HARTFORD PLANNING COMMISSION
January 13, 2025
Meeting Notice and Agenda

**Planning Commission
Administrative Agenda
January 13, 2025**

RE: RESPONSE TO STAFF COMMENTS, SUBDIVISION SERVICES, 656
MAPLE STREET, HARTFORD, VERMONT (PROJECT NO. 13445)

Our responses to the Department Heads' and Staff preliminary comments, dated December 17, 2024, are provided in *italics* below each comment.

TYPICAL WATER SERVICE CONNECTION
N.T.S.

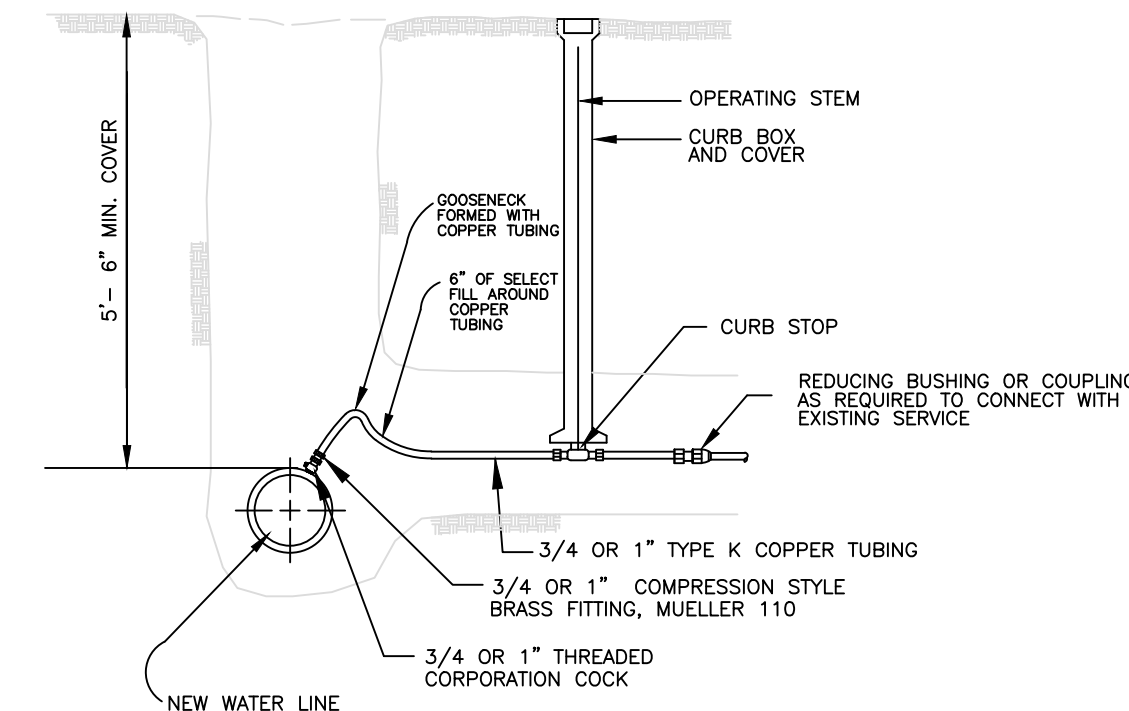
Typical Water Service Connection: The detail indicates a corporation connection to a new water main. Please revise to show connection to the existing 2" PVC main and please call out the proper fittings required.

We would like to condition the provision of utility details during the allocation process after Planning Commission approval, which will then be submitted for state review and approval.

ORTHOPHOTO FIGURE FOR
ALEX & CANDICE DEFELICE
(TAX MAP 42, LOT 16)
565 MAPLE STREET, HARTFORD, VERMONT

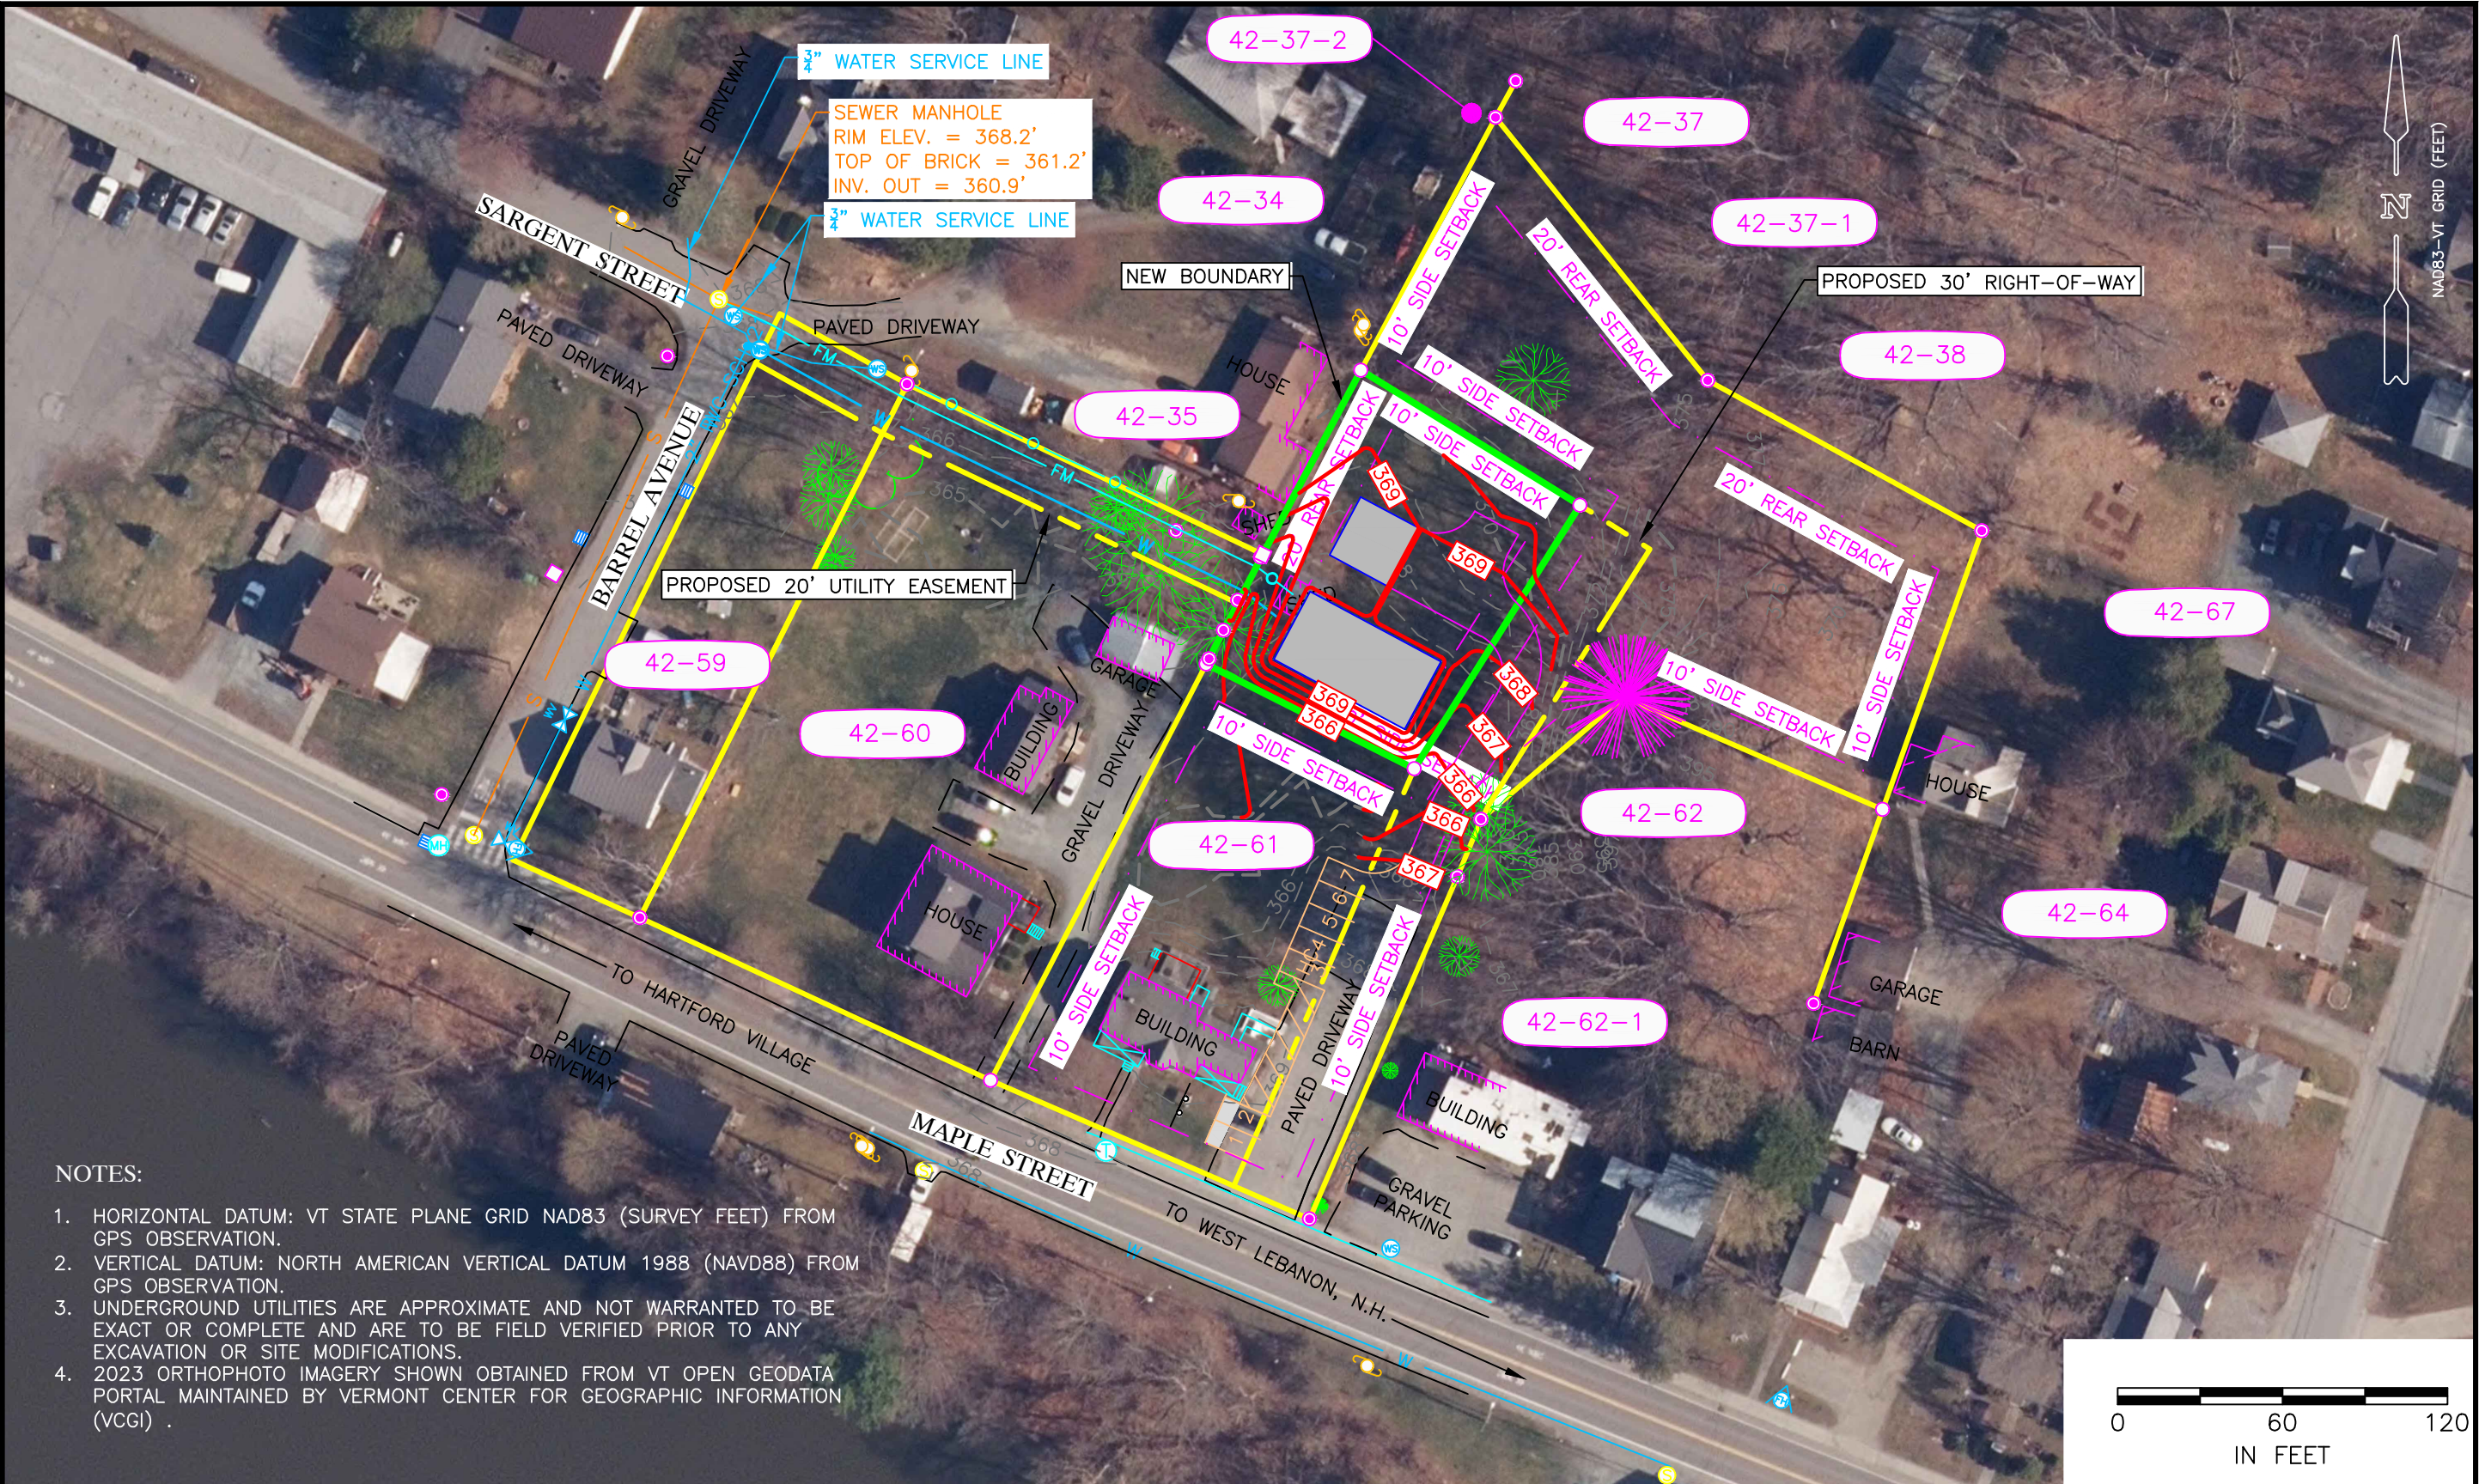
8. Please provide a deadline to bring the parking on lot 42-0061-000 into compliance with the approved site plan.

The applicant proposes to bring the commercial parking into compliance in the 2025 construction season.
